Item Name: Crosstube Turning Detail

DART AEROSPACE LTD	Work Order:	53254
Description: Crosstube Assembly (205/212/412 High Fwd)	Part Number:	D212-664-141
Inspection Dwg: D212-664-141 Rev: C		Page 1 of 1

DESIGN PH	DRAWN BY PH	DART AEROSPACE LTD HAWKESBURY, ONTARIO, CANADA	
CHECKED GP	APPROVED [Signature]	DRAWING NO. D212-664-141	REV. C SHEET 1 OF 3
DATE 07.03.08		TITLE XTUBE ASS'Y (205/212/412 HI FWD) NTS	
A	00.12.12	NEW ISSUE	
B	05.02.04	ADD HOLES FOR COMPATABILITY WITH BHT/AA SKIDTUBES	
C	07.03.08	REMOVE -851 ABRASION STRIP; ADD MAGNOBOND 6398, CUSHION, REVERSE CLAMPS

DRAWING NO. D212-664-141	TITLE CROSSTUBE	REV. C	DART AEROSPACE LTD ENGINEERING ORDER		D.E.O. NO. D212-664-141-C-1	SHEET NO. SHEET 1 OF 1	SCALE NTS
DRAWN <i>AD</i>	CHECKED <i>AD</i>	MFG. APPR. <i>AD</i>	APPROVED <i>AD</i>		DE APPR. <i>AD</i>		
DATE 09.05.01	DATE 09.06.15	DATE 09.06.15	DATE 09/06/16		DATE 09/06/16

FIGURE 1 - SUPPORT INSTALLATION

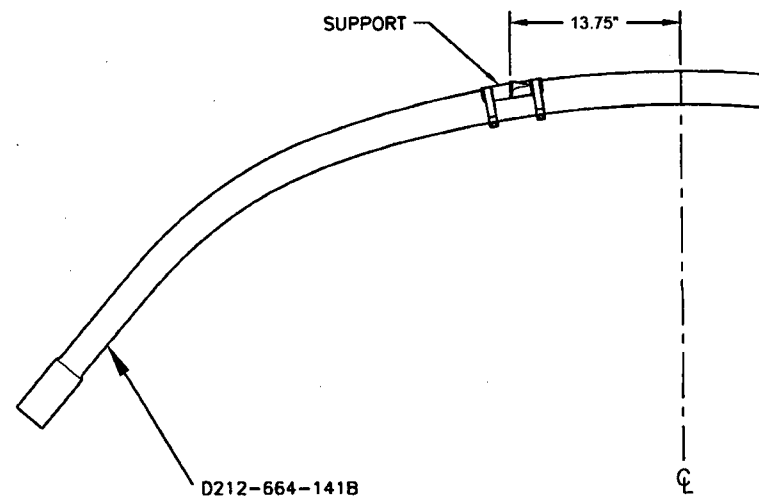
ADD THE FOLLOWING CROSSTUBE ASSEMBLY:

Part Number	Description
D212-664-141B	CROSSTUBE ASSEMBLY (214 HIGH FWD)

THE D212-664-141B CROSSTUBE HAS THE SAME PARTS LIST AS THE D212-664-141 CROSSTUBE. HOWEVER, INSTALL THE SUPPORTS AS SHOWN IN FIGURE 1 OF THIS ENGINEERING ORDER. THE NEW KIT IS OTHERWISE ASSEMBLED PER THE D212-664-141 CROSSTUBE.
